Access Compliance Report

Public Rights-of-Way

(Curb Ramps)

| Intersection ID: 10024493 | Main Street: CROWNPOINT_EXECUTIVE_DR | Cross Street: N/A | Location: NW |

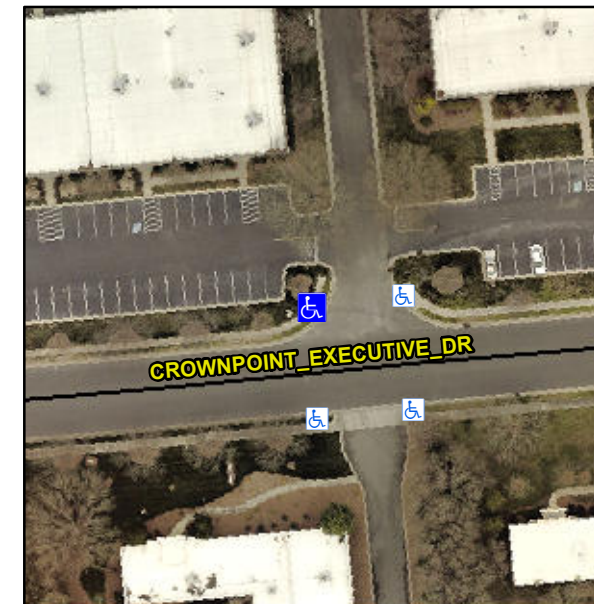
| ADA ID: C24B671F8FC3 | Ramp Type: PerpDiag | Initial Pass/Fail: Fail | Overall Compliance: No |

Not Found, R304.5.1

| Compliance | Description | Data | Compliance | Description | Data |
|------------|-----------------------|------|------------|-----------------------------|------|
| No | Ramp Width (in) | 45.0 | Yes | Ramp XSlope (%) | 0.8 |

Remove & Replace Curb Ramp With Two New Directional Ramps or Equivalent.
